TO: Brad Bingham PE, CFM FROM: Richard Waters  
COA Hydrologist EMAIL: rw@rtiabq.com  
DATE: 03 Nov, 2008  
RE: BCPW Project 80056 RTI PROJECT NO.: 08-001C Casias

## Case Comments Report

Permit: PWDN 80056

# CASIAS TRUCKING GRADING AND DRAINAGE PLAN

FIG A1 - View West from 98th St Road, showing  
Paved curb and inverted crown on Central Ave  
Frontage Rd

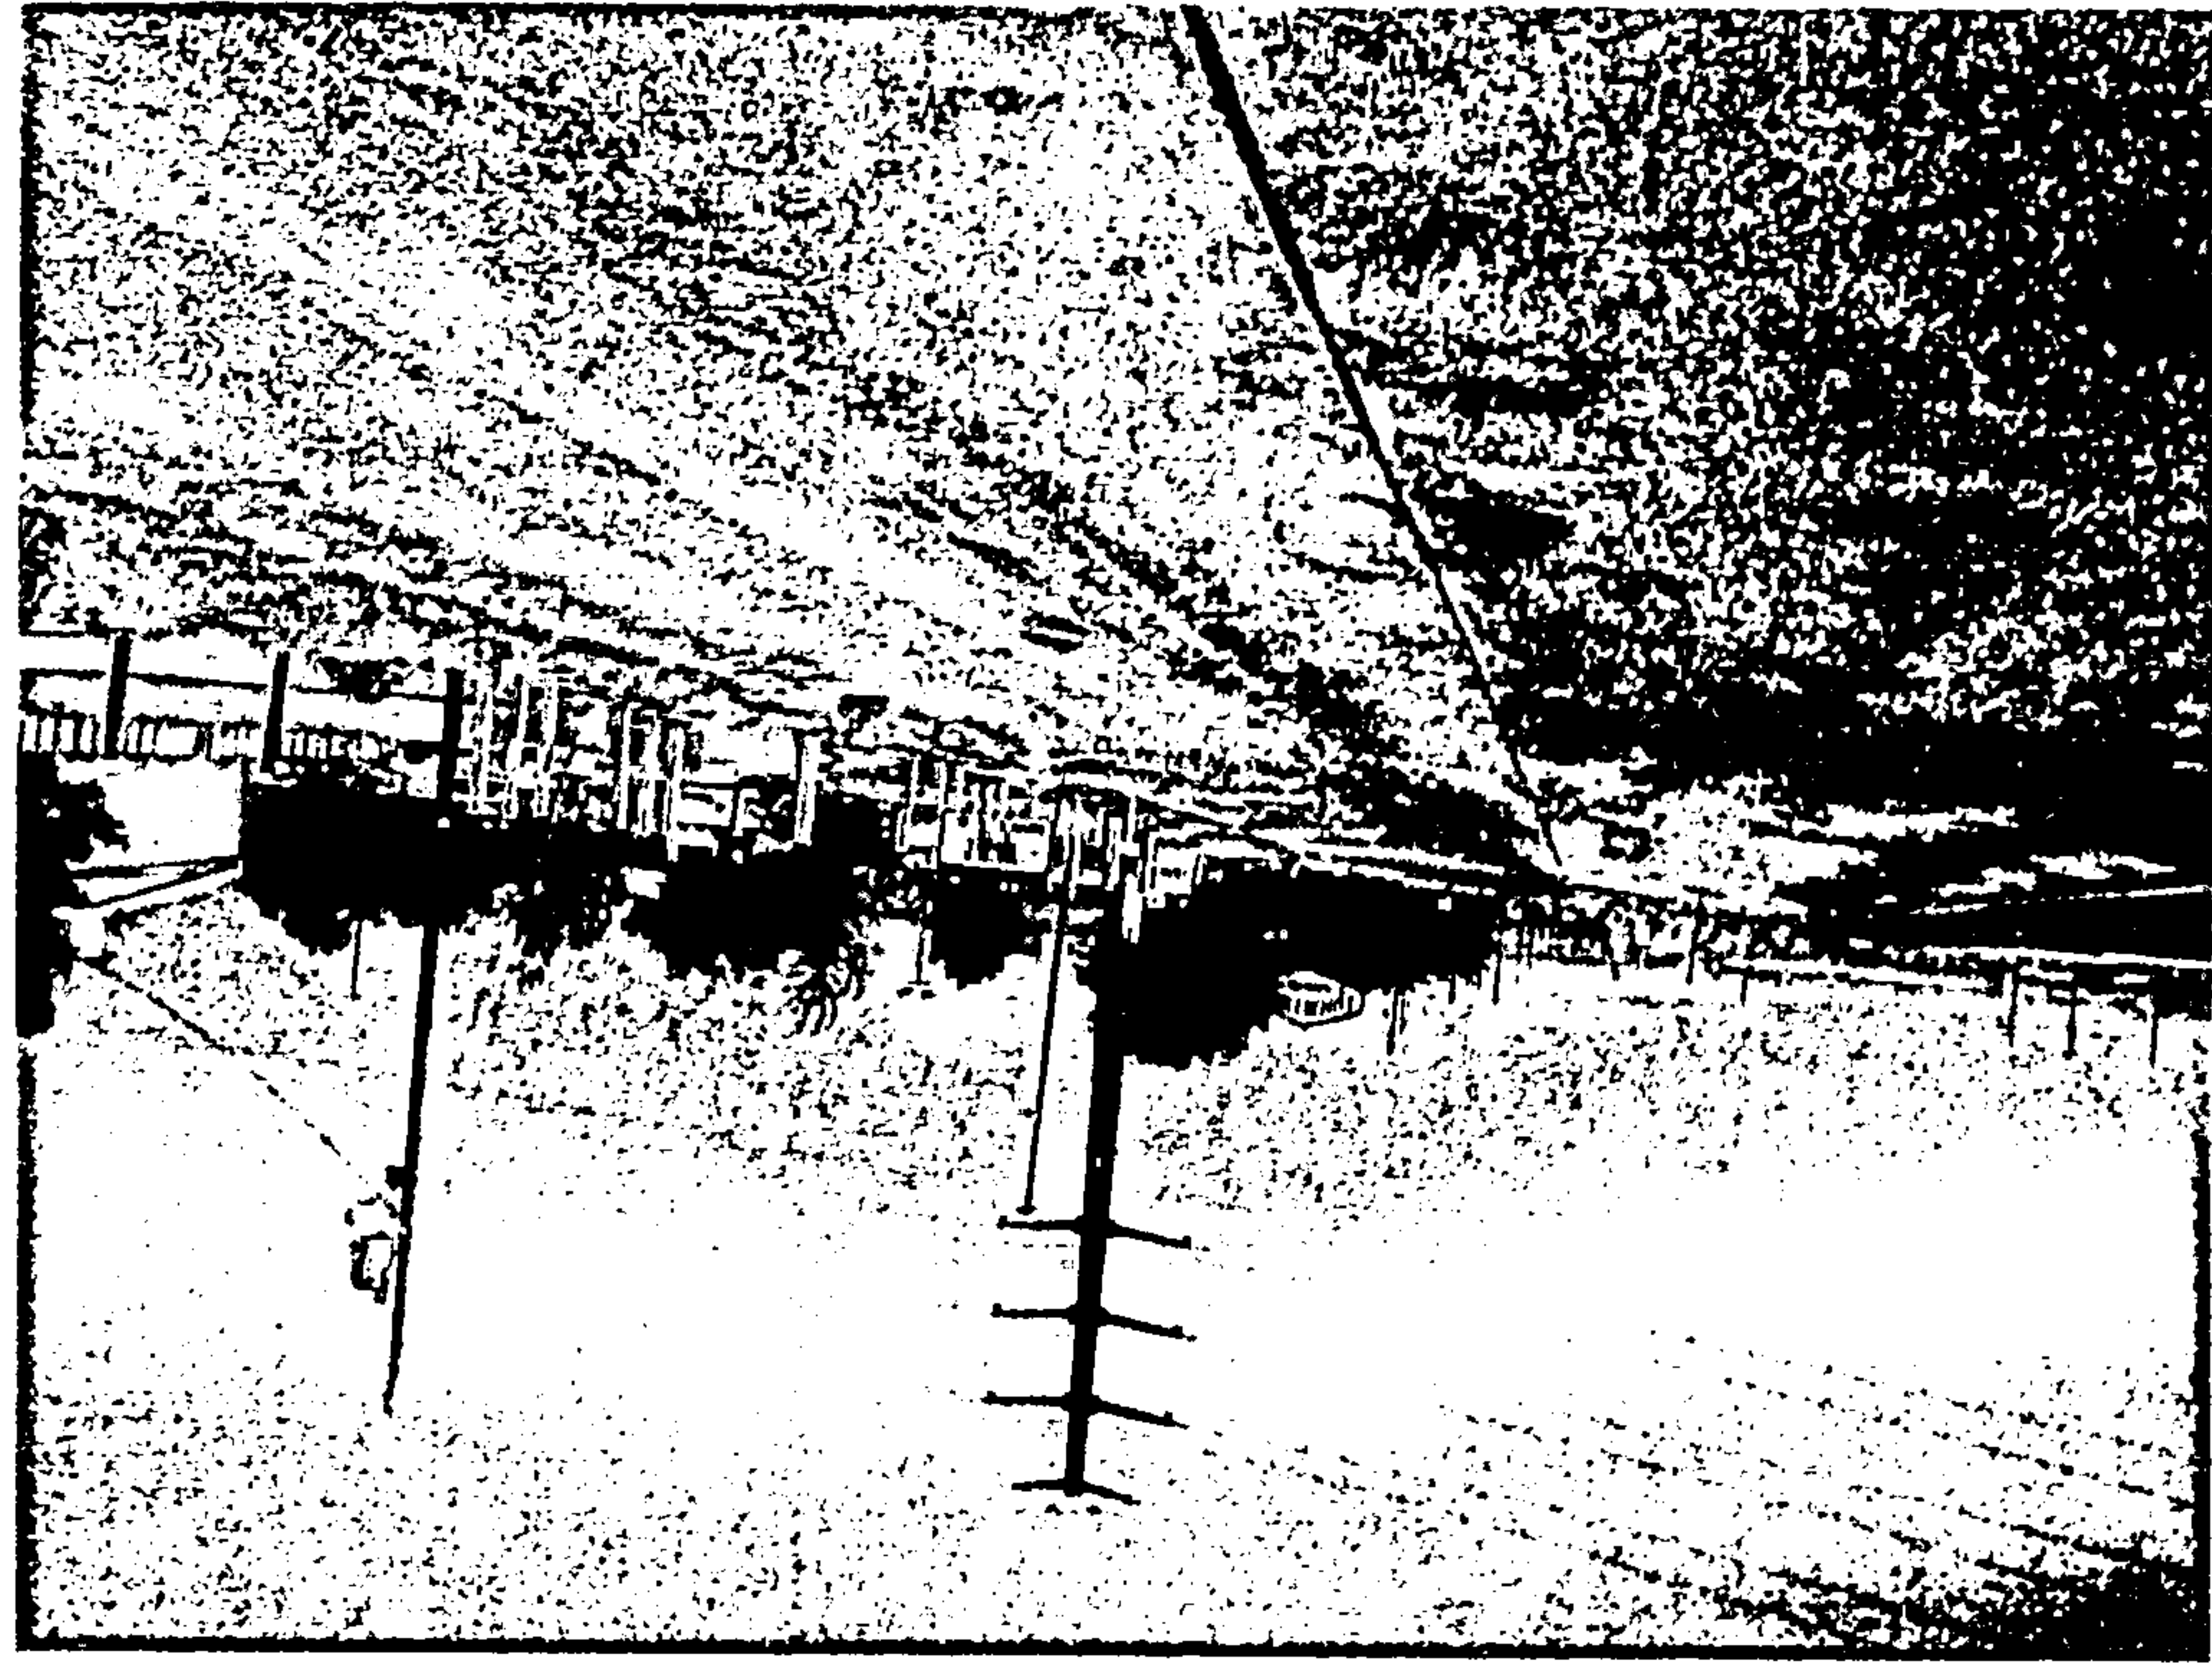
4. Provide documentation from The City of Albuquerque that free discharge to Central Ave. will be allowed ~~as described in the 2003 drainage report.~~

- #1) Vicinity map from zone atlas included.
- #2) Current FIRM (dated 9/26/08) included.
- #3) Site visit was made on 5/12/08. Certification included.
- #4) See Attachment A "Design Report Phase IIIc" pages 5 and 6, and accompanying photos.
- #5) The construction site in this request is approximately 1800 sq. ft. and does not disturb enough ground to require a SWPPP.
- #6) The property owner will coordinate fugitive dust permit with BCPW.
